Energy Storage and Distributed Energy Resources (ESDER) Phase 3

Revised Straw Proposal

Comments by Department of Market Monitoring

July 6, 2018

1) Facility load profile:

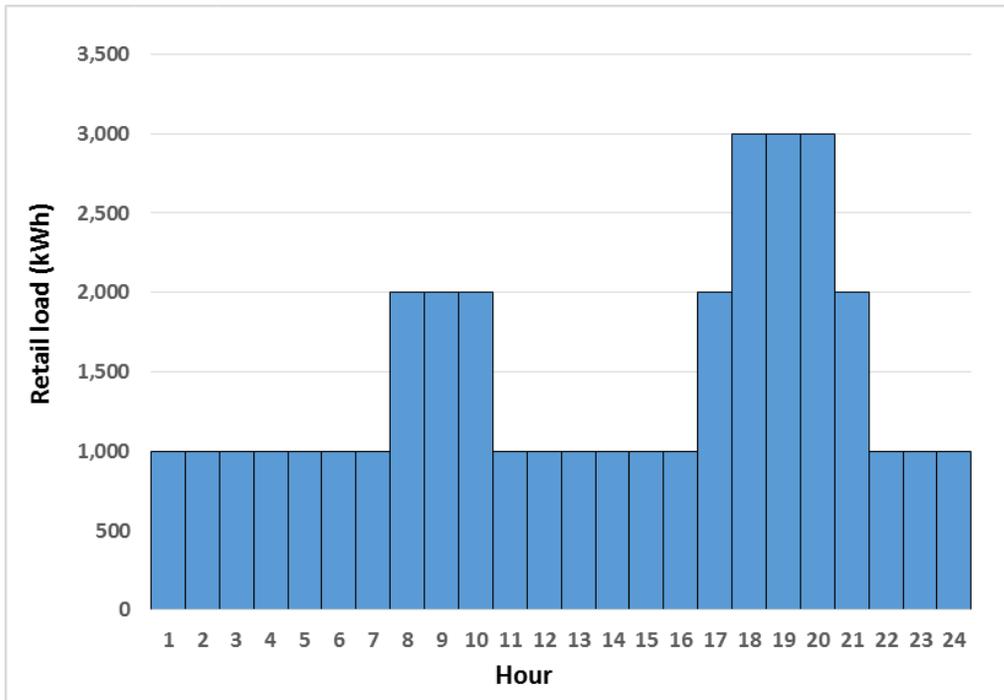
- For traditional DR to increase its baseline, it must increase load above its typical profile and incur additional retail charges; For PDR-LSR to alter its baseline, the storage component of a PDR-LSR could simply shift charging to other intervals that it would have performed regardless without impacting its retail settlement.
- A storage asset can also act independently of its host load and serve part of its load with stored energy, charging at retail and offsetting retail demand in other intervals. So PDR-LSR can meet the same load profile as a traditional DR asset at the same retail cost, but operate in a way that also optimizes its baseline.

This second issue is illustrated by the example in the following figures. In this example, assume a flat retail rate of \$0.15/kWh. As shown in the following example, with storage, the PDR-LSR facility load can still be met at the same retail cost, but the storage device can effectuate a favorable consumption baseline in midday hours in the process.

DMM appreciates the complexity and challenges in designing effective baselines for behind the meter resources that participate in the wholesale market. DMM suggests that the ISO continue to study alternative baseline approaches that eliminate incentive issues, which could be utilized in the future for resources with behind the meter storage.
